**DECLARATION FOR THE EXPLANATION OF  
SIGNIFICANT DIFFERENCES  
FOR CONTINUED STORAGE OF HOT SPOT SEDIMENTS**

New Bedford Harbor Superfund Site (Hot Spot Operable Unit)  
Bristol County, Massachusetts

Explanation of Significant Differences  
for Continued Storage of Hot Spot Sediments

October 1995

FIGURE 4 - CDF CELL #1 CROSS-SECTIONS

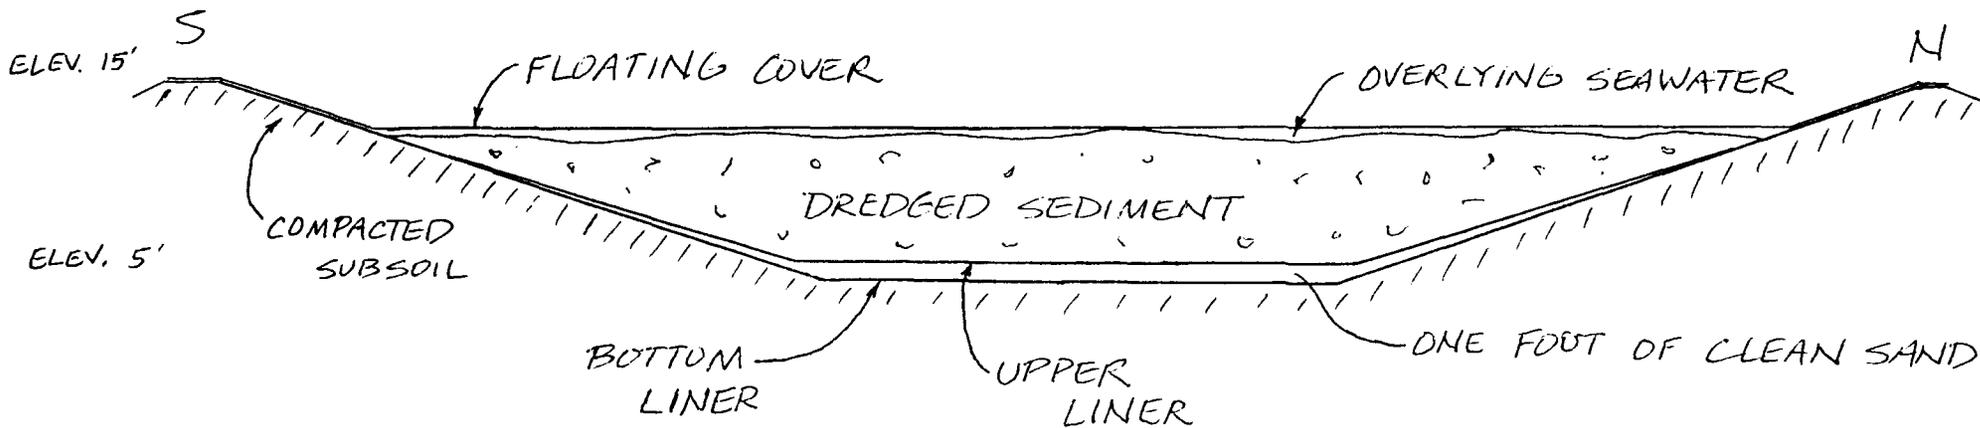
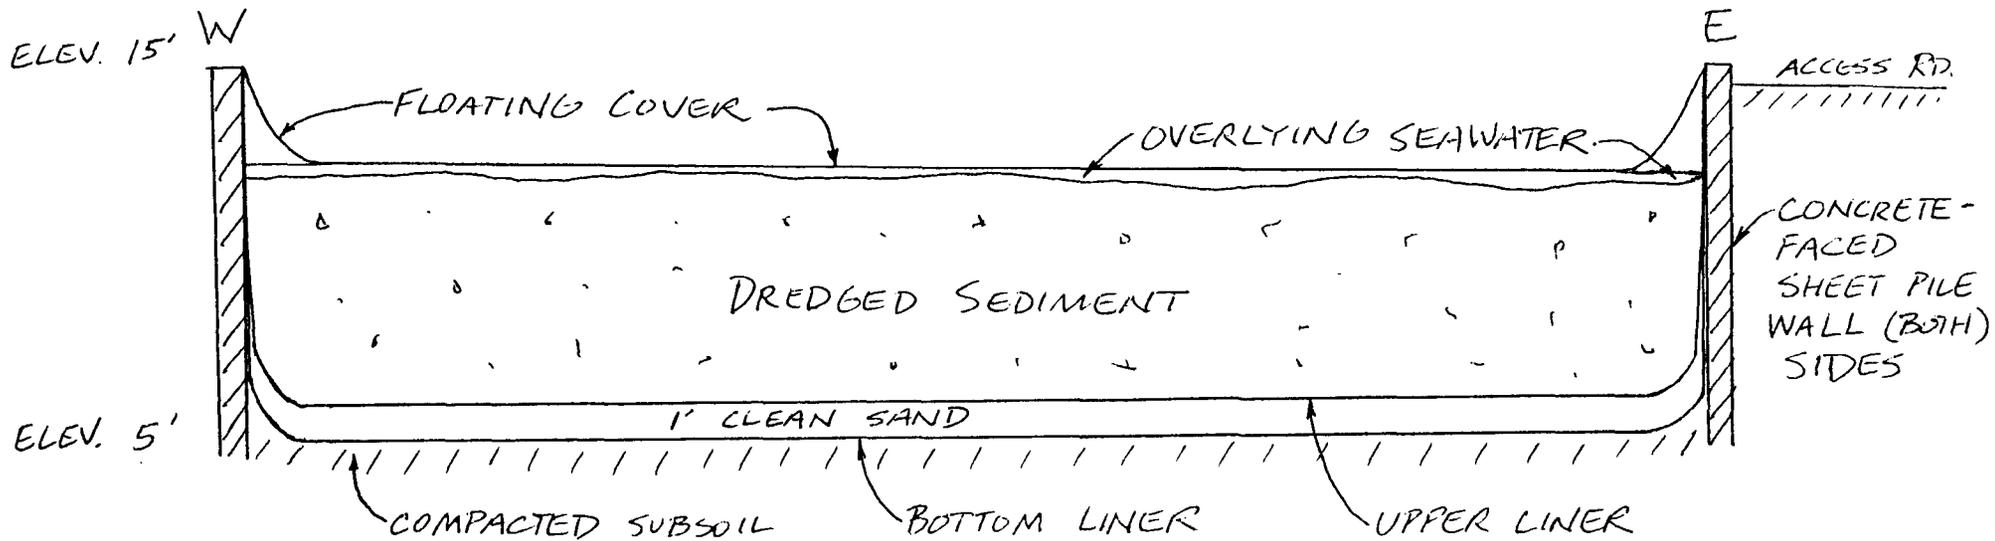
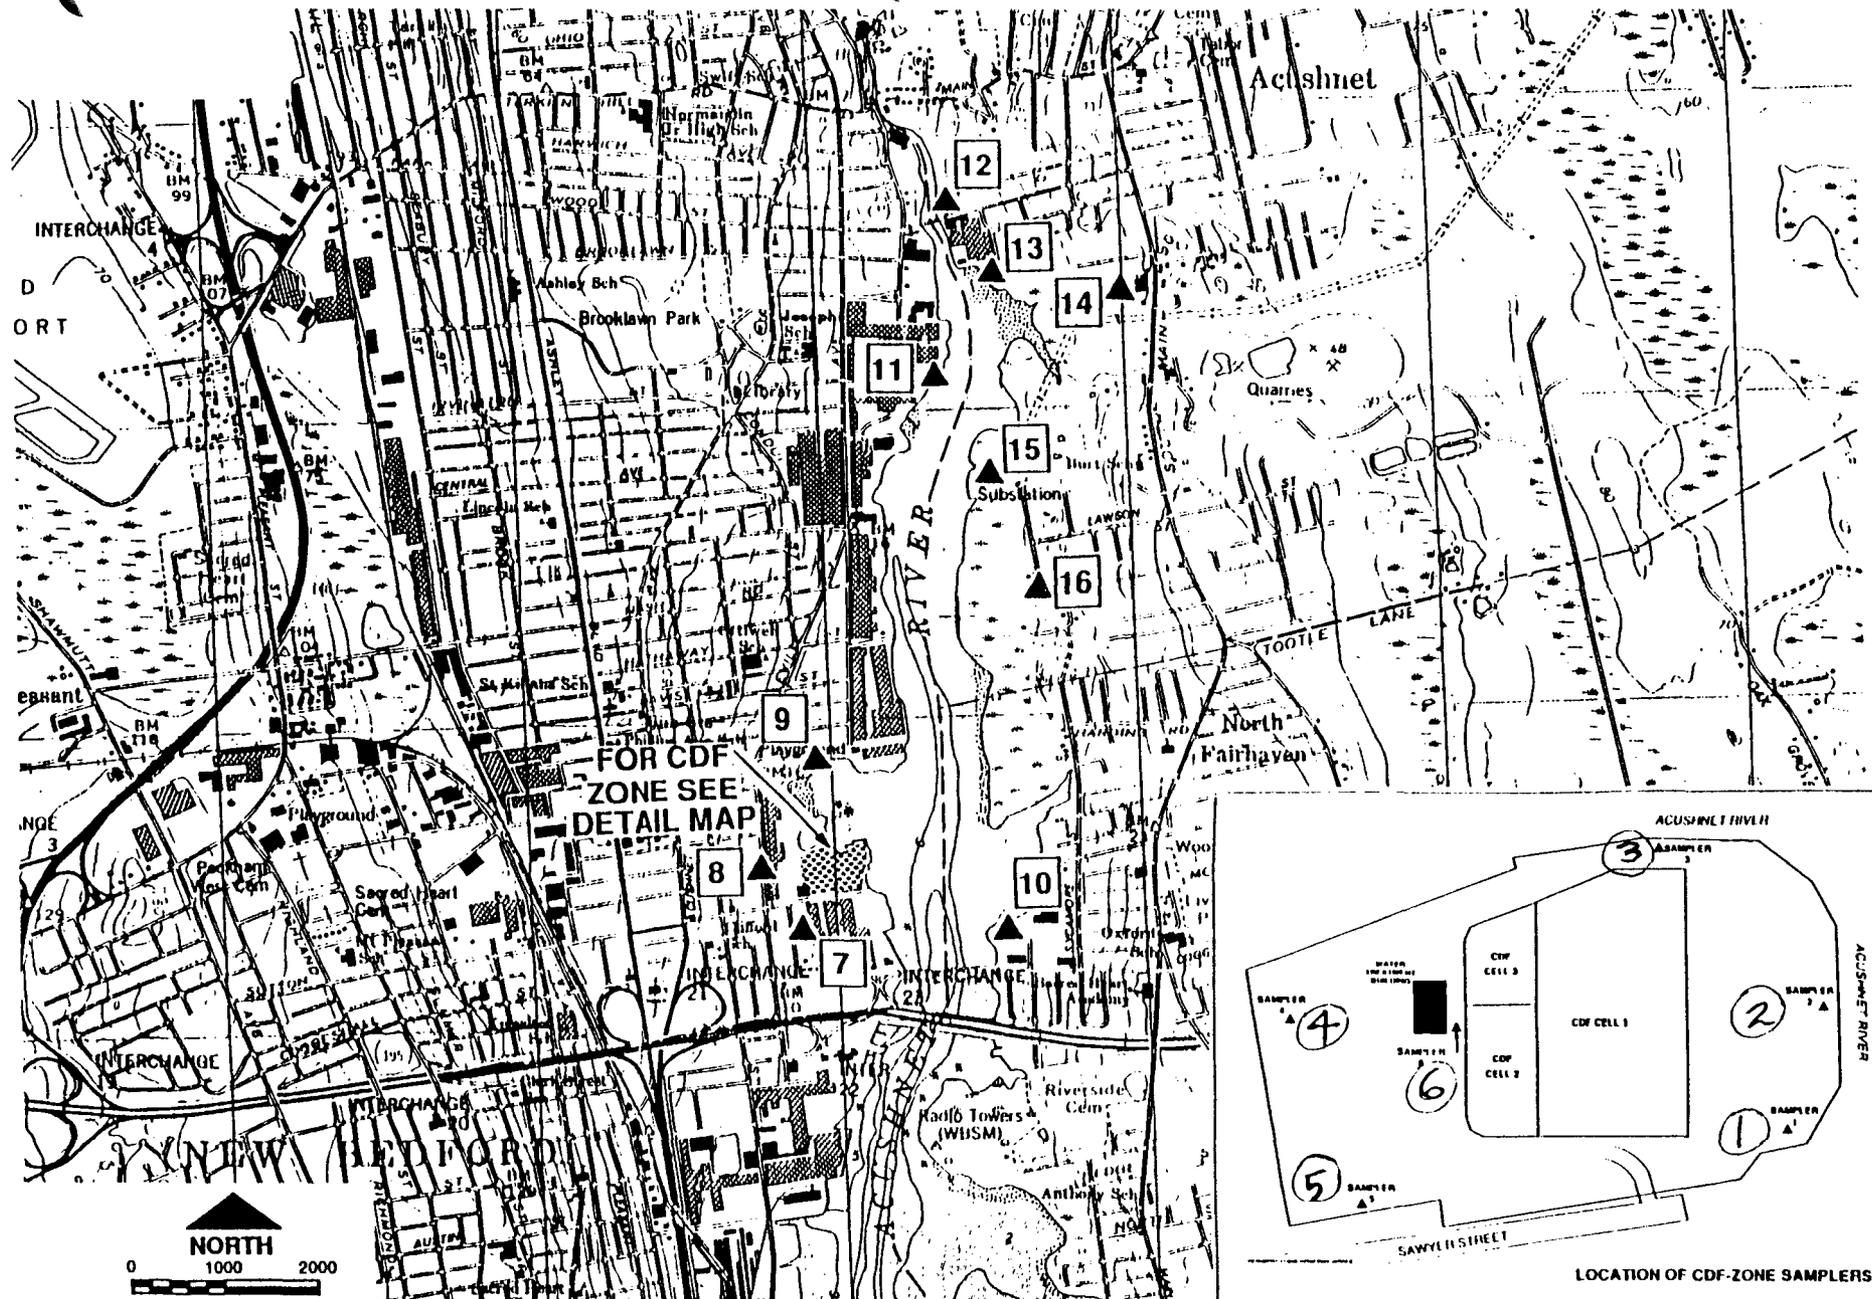
First, the construction of cell #1 was modified to include two, rather than one, impermeable liners. Both liners are constructed of high-density polyethylene (HDPE), a standard material used for long-term control of hazardous wastes. The bottom-most liner is 80 mils thick, and the upper liner is 60 mils thick (a mil is one-thousandth of an inch). All liner seams were extensively tested during installation. HDPE liners are typically expected to last for 30 years or more, so they are expected to retain their integrity over the estimated five year period of interim untreated sediment storage. Figure 4 contains two "cross-section" drawings of cell #1 which illustrate the as-built construction of all cell #1 components, including the two bottom HDPE liners. The location of these two cross-sections within cell #1 is shown on Figure 2.
